Flight Procedures Cover Page	Task Action: FLIGHT CHECK	Task Type: IAP	Estimated Chart Date: 12/02/2021	APWS Task ID: 83C0A40D6F9F46A4909FB2126DDE1392	APWS Project ID: 93DEC047914E49CA9AA789771C1AF327
Procedure: RNAV (GPS) RWY 25 AMDT 1		Enroute: NO	Specialist: Young, Silvia		Agreement Number:
Airport ID: KOKB			Airport City: OCEANSIDE		State: CA
Facility ID:	Facility Type:	Flight Inspection Remark Type: New FC Slot

FIPC BASIC FORM							
PROCEDURE: RNAV (GPS) RWY 25 AMDT 1			AIRPORT NAME: BOB MAXWELL MEML AIRFIELD		AIRPORT ID: KOKB	SPECIAL CONTROL NO: SG-07-230-21	
FAC ID: KOKB25.01		CITY: OCEANSIDE			ST: CA	ORIG CHART DATE: 12/02/2021	
DFL TYPE: PROC/G	THIRD PARTY: <input type="checkbox"/> YES	EST. TIME ON SITE: 0.5	REIMB. NUMBER:		PTS TASK ID:		
PREFLIGHT NOTES							
REVIEWER: john d jeffers					DATE: 08/20/2021		
COMMENTS:					CHECK ONE:		
					<input checked="" type="checkbox"/> FLT CK REQ <input type="checkbox"/> NFCR <input type="checkbox"/> REJECT		
							YES
					CPV COMPLETE?		X
PROCEDURE RESULTS							
INSPECTION DATE: 08/17/2021		CREW #: VN086	N #: N68	INSTRUMENT PROCEDURE STATUS: <input checked="" type="checkbox"/> SAT <input type="checkbox"/> SAT W/CHANGES <input ty

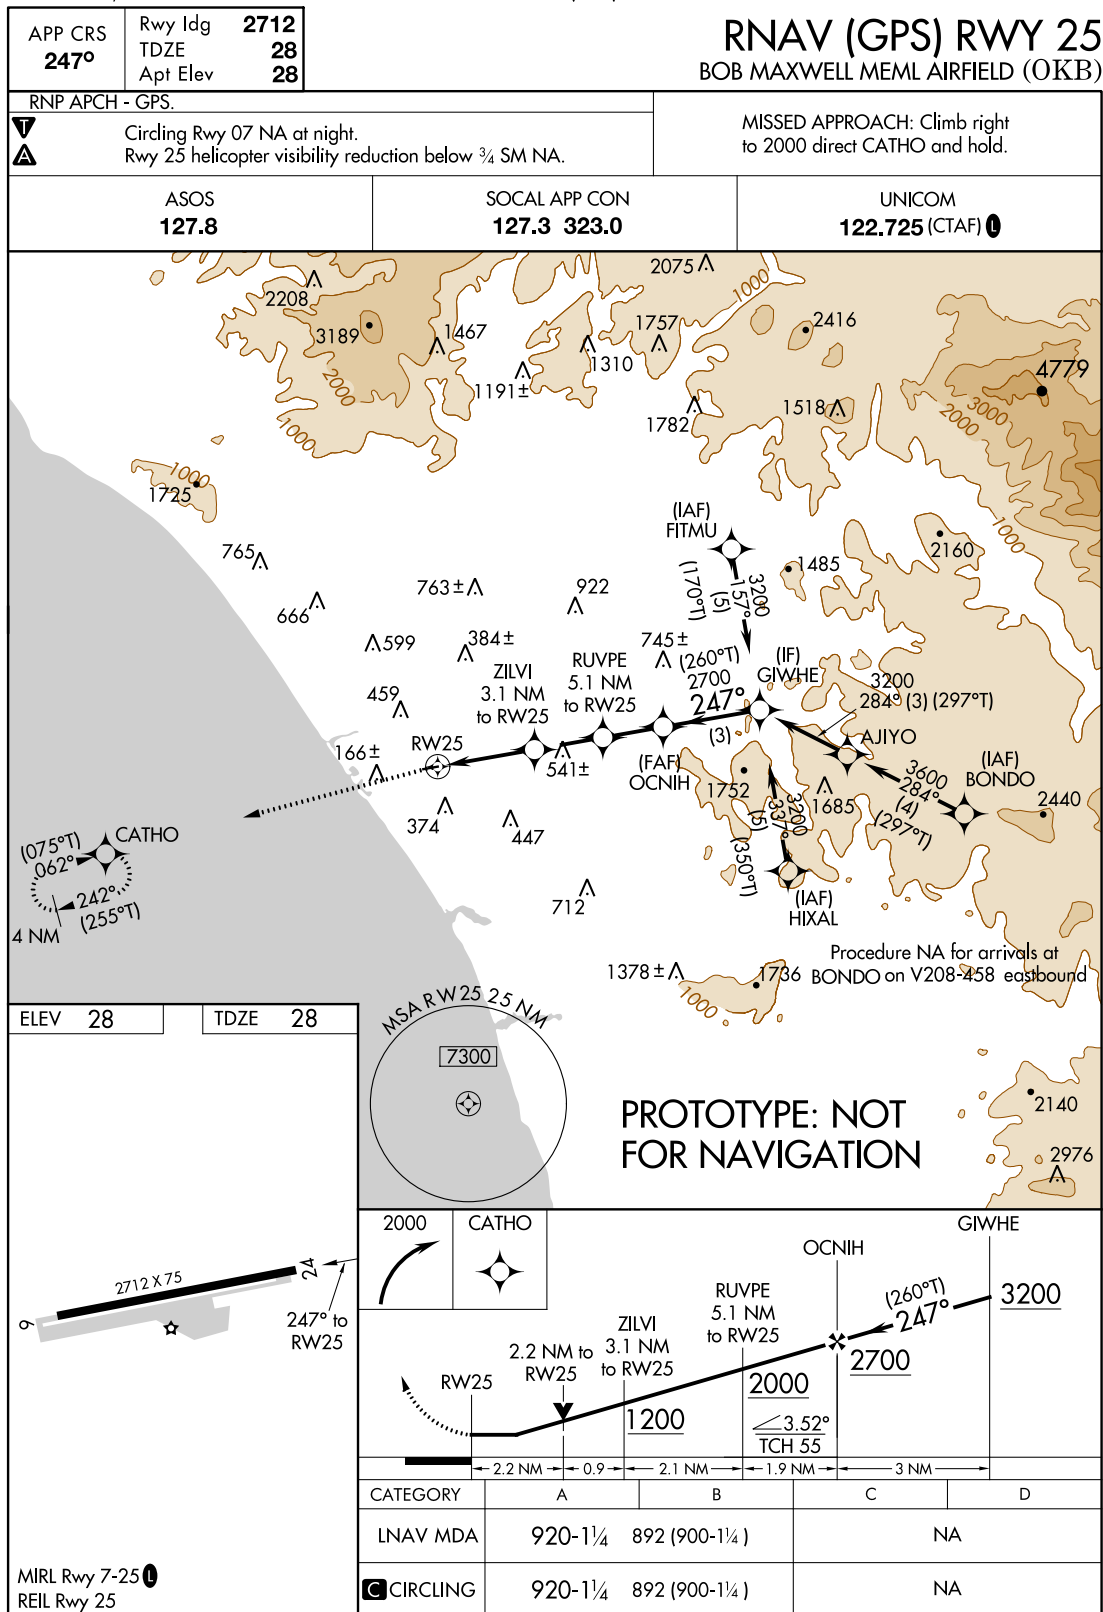
10/01/2021: THIS IS A CORRECTED COPY OF THE FORM APPROVED ON 08/30/2021.

1. MISSED APPROACH INSTRUCTIONS: CHANGED FROM "CLIMB RIGHT TO 2000 DIRECT CATHO AND HOLD." TO "CLIMB TO 2000 DIRECT CATHO AND HOLD".

RNAV (GPS) RWY 25:

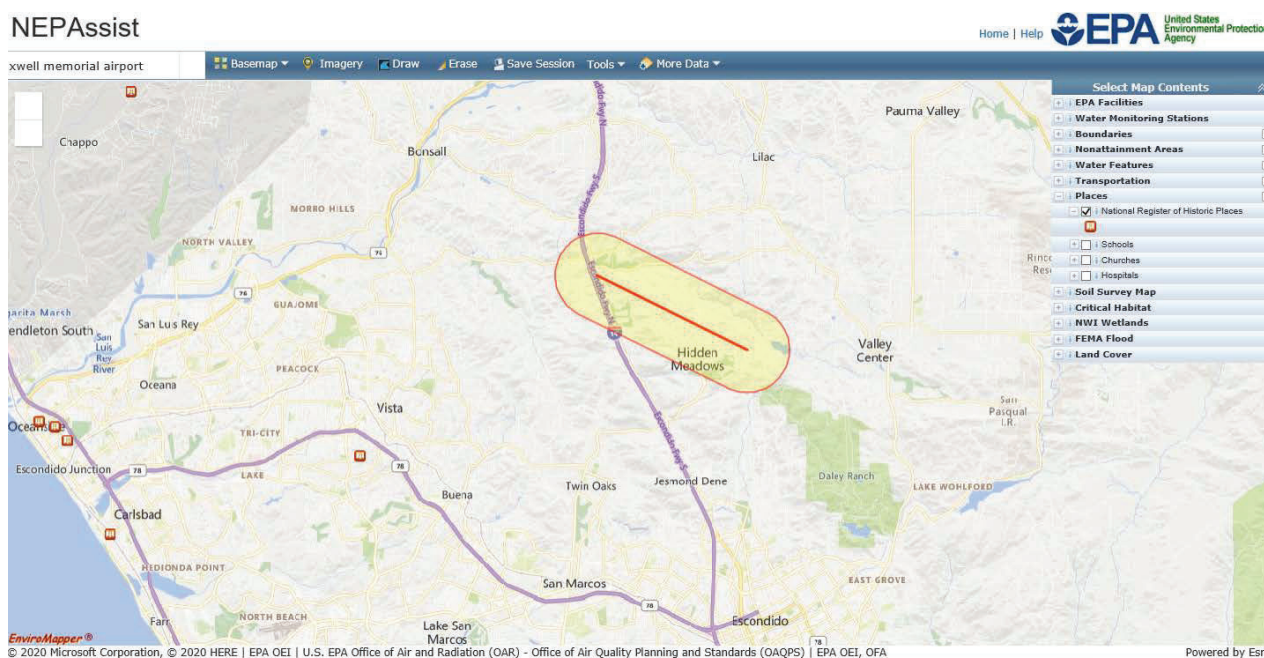
The procedure name change from RWY 24 to RWY 25. The following are amendments to the procedure.

- Initial segments
 - FITMU initial approach fix (IAF) to GIWHE waypoint (WP)—no change
 - HIXAL IAF to GIWHE WP—minimum altitude increased from 2,900 to 3,000 (ft) mean sea level (MSL), no location change.
 - BOND0 IAF to AJIYO step-down fix (SDF) to GIWHE WP—minimum altitude from BOND0 IAF to AJIYO SDF unchanged, minimum altitude from AJIYO SDF to GIWHE WP decreased from 3,100 to 3,000 ft MSL, no fix locations changed.
- Intermediate segment—GIWHE WP minimum altitude increased from 2,900 to 3,000 ft MSL. No change in location.
- Final segment—OCNIH precision final approach fix (PFAF) moved 2 nautical miles east to N33° 14' 20.1943" W117° 12' 36.2841" and minimum altitude increased from 1,800 to 2,500 ft MSL.

The only segment of the entire project being lowered is the segment from AJIYO to GIWHE and that is by 100 ft (from 3,100 to 3,000 ft MSL).
